Application No.: 10/630072
Amendment dated: September 9, 2004
Reply to Office action of March 9, 2004

REMARKS/ARGUMENTS

AMENDMENT TO THE DRAWINGS

Fig. 5

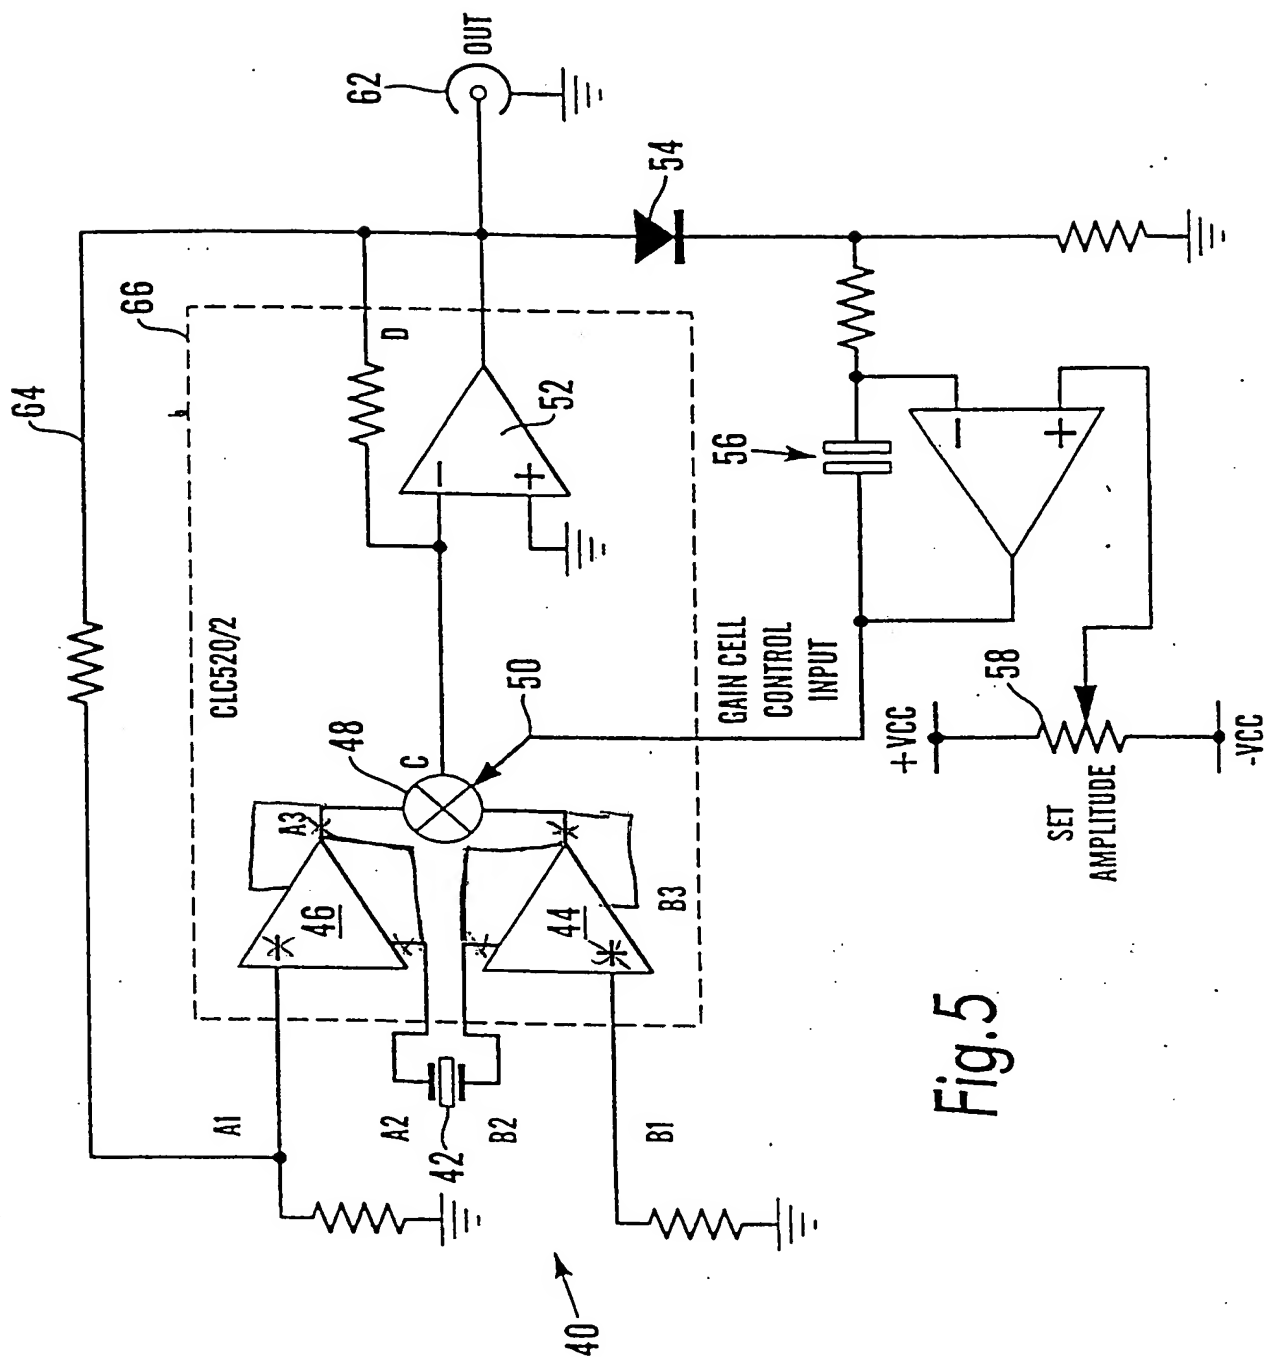
Please substitute the attached replacement sheet bearing FIG. 5 for the corresponding original drawing sheet. An annotated sheet showing the changes is also attached. The change is the interchange of the outputs of each of the two buffers. This change brings FIG. 5 into conformity with FIG. 4a, as required by paragraph 0034.
